DEVELOPMENT REVIEW BOARD MEETING

**DEVELOPMENT REVIEW BOARD
RESOLUTION NO. 441**

Exhibit A1
Planning Division Staff Report
Class 3 Sign Permit and Wall Mural for ParkWorks

Hearing Date:	July 28, 2025
Date of Report:	July 21, 2025
Application No.:	DB25-0002 Class 3 Sign Permit and Wall Mural Review
Request/Summary:	The Development Review Board is being asked to review a Class 3 Sign Permit, Waiver, and Site Design Review for ParkWorks
Location:	26600 SW Parkway Avenue. The property described as Tax Lot 00511, Section 12, Township 3 South, Range 1 West, Willamette Meridian, City of Wilsonville, Clackamas County, Oregon.
Owner:	SKB-Parkworks LLC (Matt Moravi)
Applicant:	Danny Riordan, Tube Art Displays, Inc.
Authorized Representative:	Scott Caufield, Scott Caulfield Enterprises
Comprehensive Plan Designation:	Industrial
Zone Map Classification:	PDI (Planned Development Industrial)
Staff Reviewer:	Georgia McAlister, Associate Planner

Proposed 355 sq. ft. sign

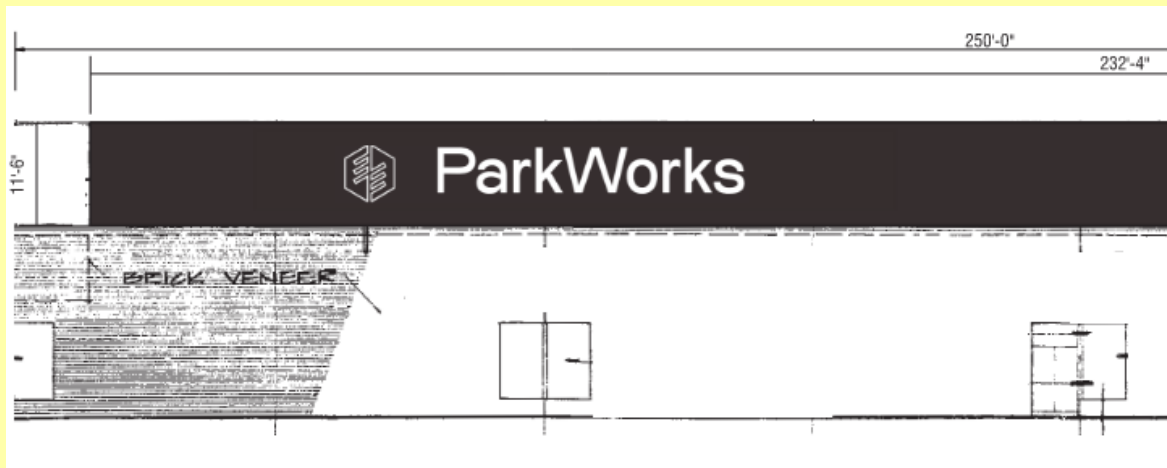
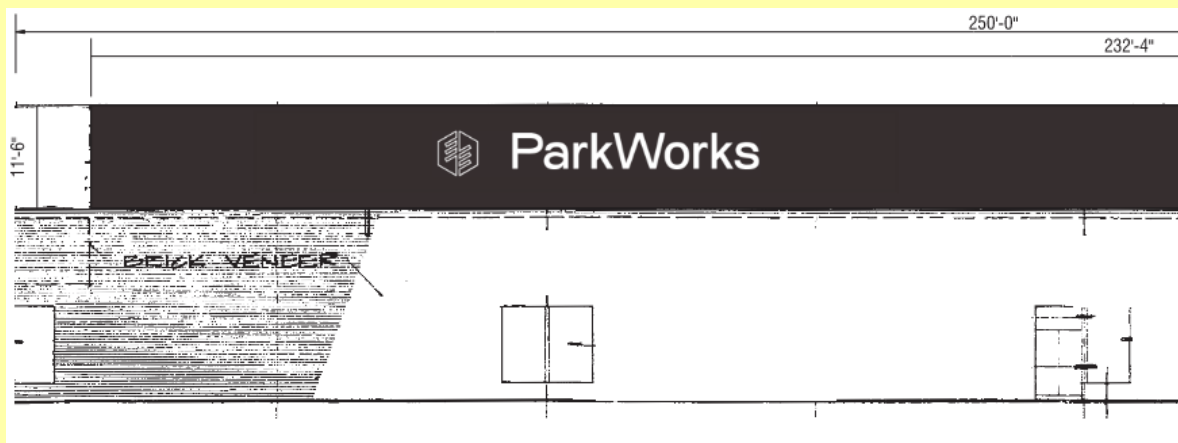
The three images above demonstrate how the relationship between the size of the sign and the architectural feature in which they are placed changes the visual impact of the sign. In the first image the 355 sq. ft. sign dominates the parapet and does not appear to be balanced. Whether there is sufficient definable space is questionable as the sign appears to be “pushing” against the upper edge of the parapet.

The second image illustrates the staff’s recommendation to limit the extent of the waiver to allow for a maximum of 200 sq. ft. The 200 sq. ft. sign balances positive and negative space appropriately. There is noticeable definable space between the sign and the edges of the parapet. The sign does not appear to dominate the architectural feature but instead it adds interest to an otherwise plain façade enhancing the design.

The third image depicts the sign at 132 sq. ft., the maximum allowed sign area based on the length of the façade. The smaller sign does not fill the parapet as well as the 200 sq. ft. sign.

While there is definable space, an argument can be made that too much is provided throwing off the balance between the positive and negative space.

PDA 1.	Ongoing: The approved sign shall not exceed 200 sq. ft. and be installed in a manner substantially similar to the sign approved by the DRB and stamped plans approved by the Planning Division.
PDA 2.	Prior to Installation: The applicant shall submit a Class 1 Sign permit including drawings demonstrating compliance with the DRB approval

Proposed 355 sq. ft. sign

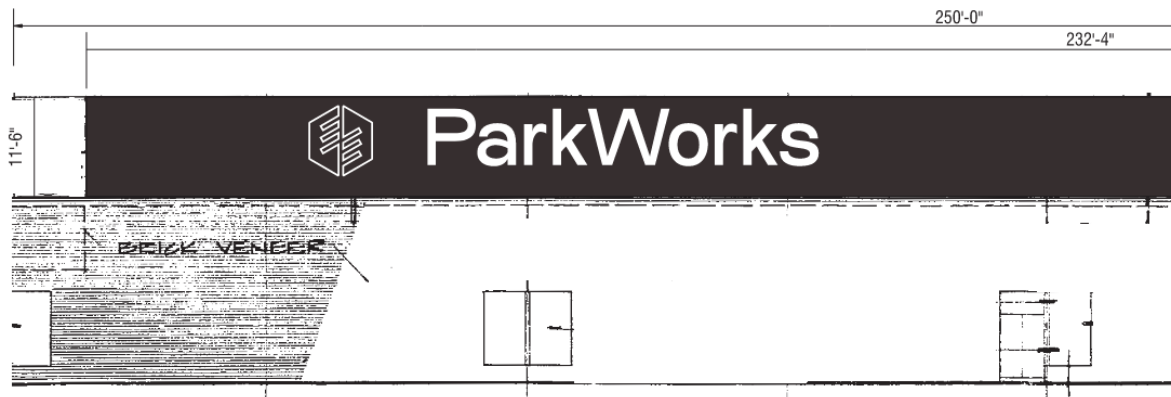
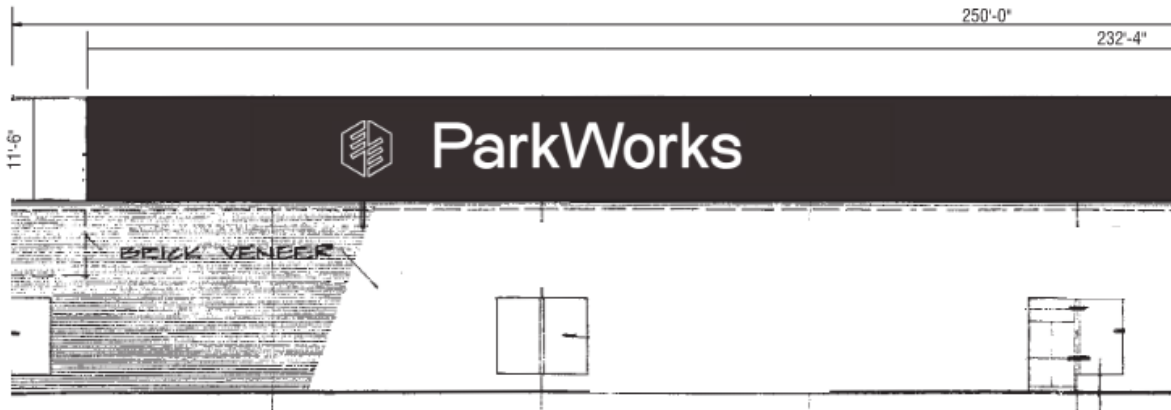
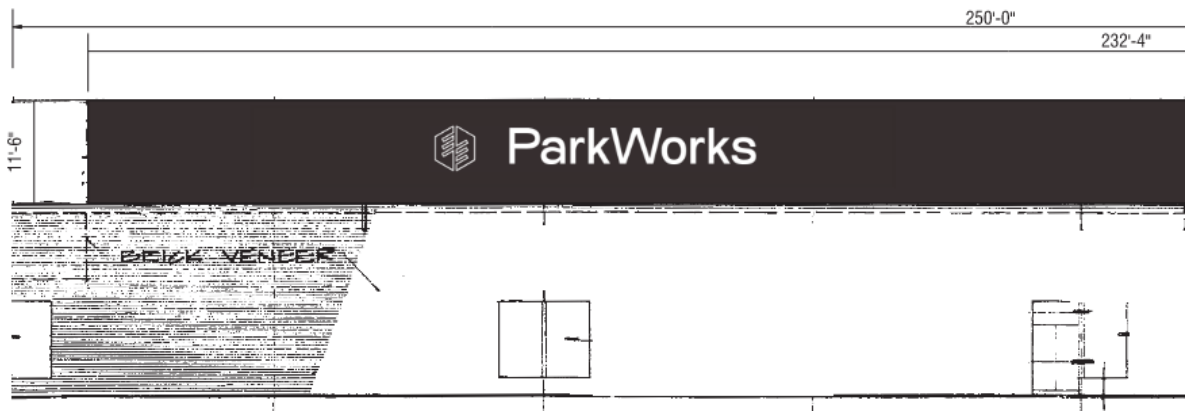
The three images above demonstrate how the relationship between the size of the sign and the architectural feature in which they are placed changes the visual impact of the sign. In the first image the 355 sq. ft. sign dominates the parapet and does not appear to be balanced. Whether there is sufficient definable space is questionable as the sign appears to be “pushing” against the upper edge of the parapet creating a constricted feeling.

The second image illustrates the staff’s recommendation to limit the extent of the waiver to allow for a maximum of 200 sq. ft. The 200 sq. ft. sign balances positive and negative space appropriately. There is noticeable definable space between the sign and the edges of the parapet. The sign does not appear to dominate the architectural feature but instead it adds interest to an otherwise plain façade enhancing the design.

The third image depicts the sign at 132 sq. ft., the maximum allowed sign area based on the length of the façade. The smaller sign does not fill the parapet as well as the 200 sq.

ft. sign. While there is definable space, an argument can be made that too much is provided throwing off the balance between the positive and negative space.
